DRAFT- DOH Review: Navy Groundwater Flow Models & Related Issues with the Navy CSM for the Red Hill Facility

The Department of Health Hawaii (DOH)
Technical subject matter experts
Robert Whittier, Don Thomas, G.D. Beckett & Anay Shende

In coordination with EPA, Region 9

October 19, 2021

Navy 3D Lithologic Model – Barrel Logs

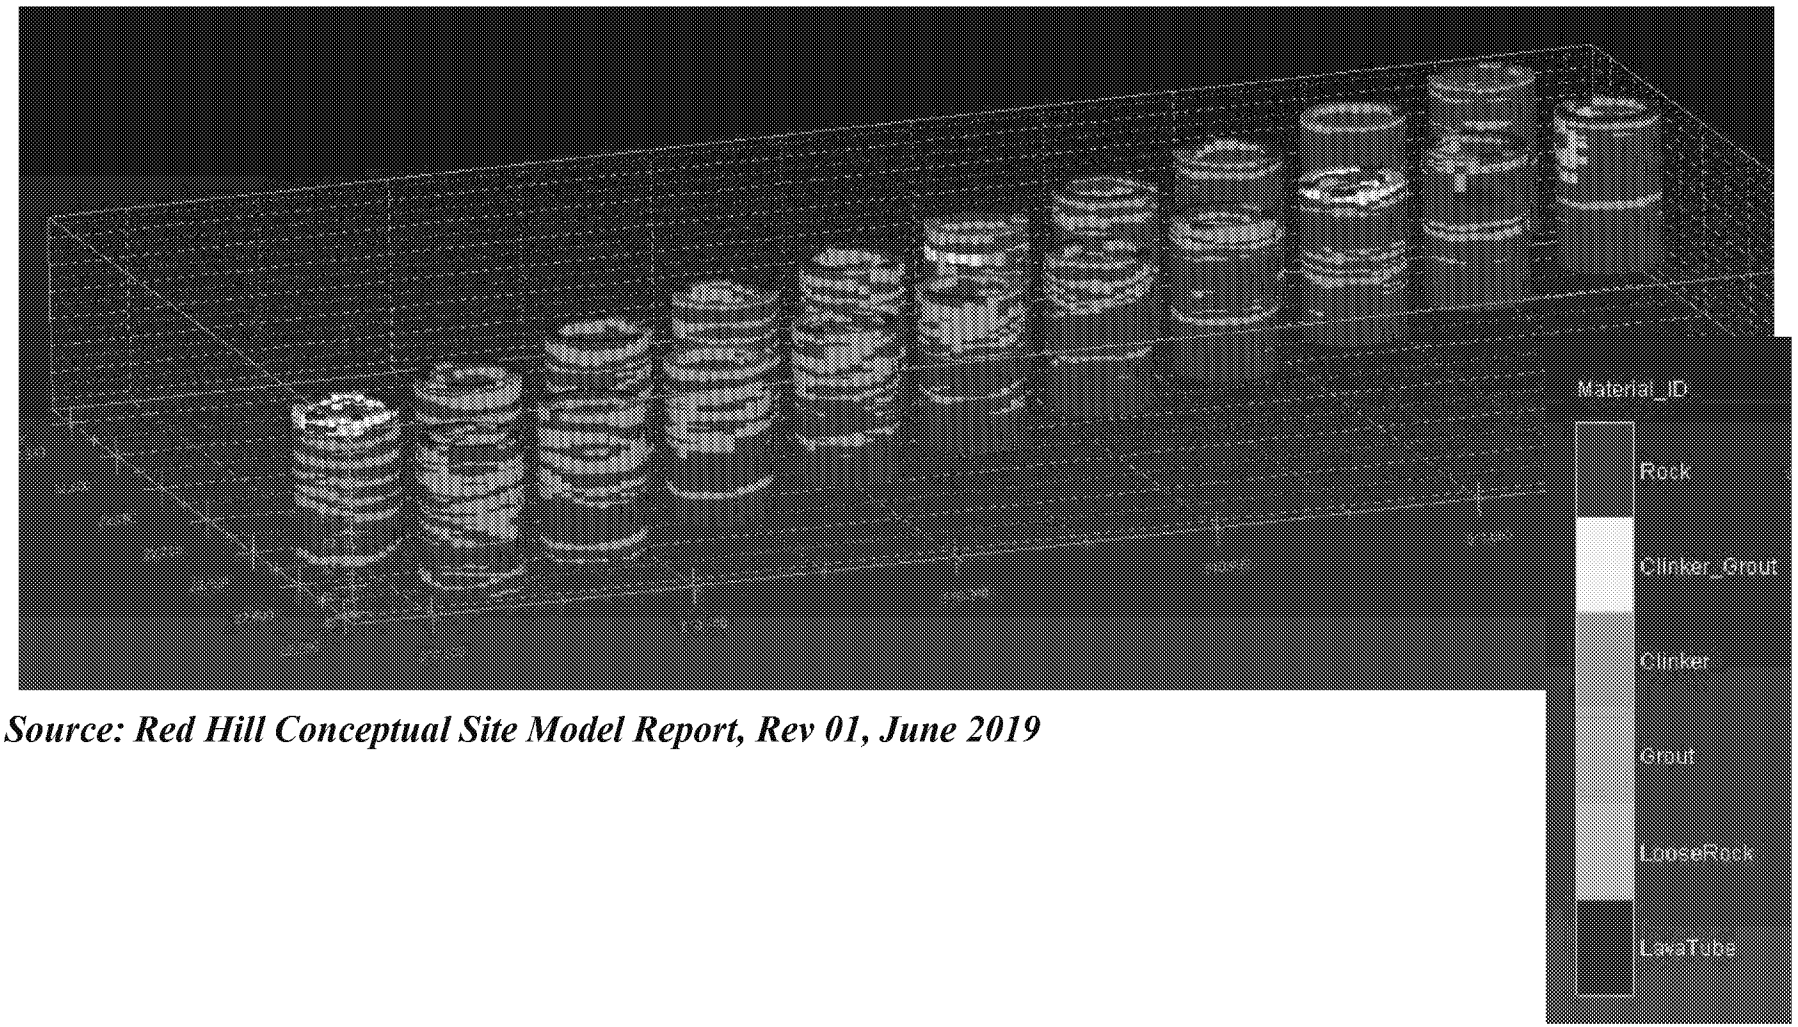
(same issue, Dr. Tonkin will address)
